Proposal for amendments to ECE/TRANS/WP.29/GRVA/2020/8

Note: This informal document is combining the proposed changes of ECE/TRANS/WP29/GRVA/2020/8 with the adopted changes in ECE/TRANS/WP.29/GRVA/2019/24, agreed in the September 2019 GRVA session

Paragraph 5.6.4.6.4, amend to read:

ACSF C – Case where the lateral movement is initiated automatically (1 Step HMI)

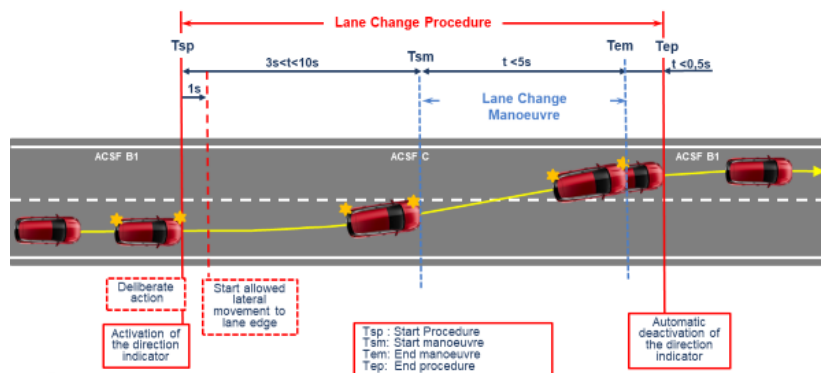
5.6.4.6.4.1. Automatic initiation of the lane change manoeuvre

In case of an automatic initiation the lane change manoeuvre shall commence between 3.0 seconds and ~~10.0~~ **10.0** seconds after the manual activation of the procedure as described in paragraph 5.6.4.6.2. and shown in the Figure below. **The manoeuvre shall commence at the earliest opportunity when the situation is not deemed critical as defined in 5.6.4.7.**

ACSF C – Case where the lateral movement is initiated by a second deliberate action by the driver (2 Step HMI)

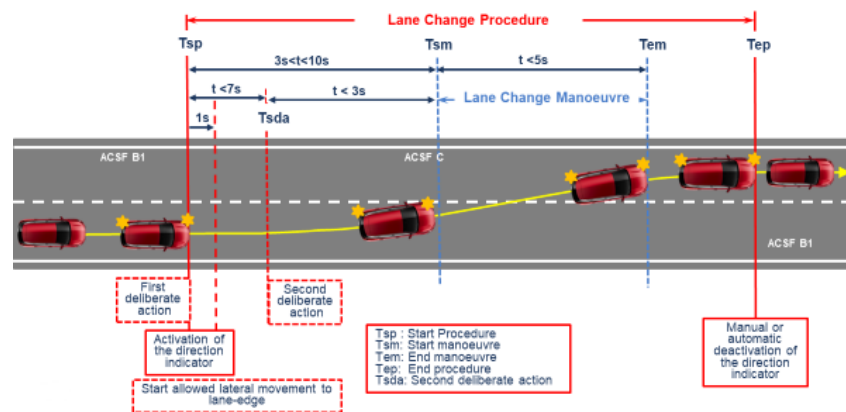
5.6.4.6.4.2. Initiation of the lane change manoeuvre by a second deliberate action

In case of an initiation by a second deliberate action the lane change manoeuvre shall commence between 3.0 and ~~10.0~~ **10.0** seconds after the manual activation of the procedure as described in paragraph 5.6.4.6.2.

Additionally, the lane change manoeuvre shall commence at the latest 3.0 seconds after the second deliberate action as shown in the Figure below.
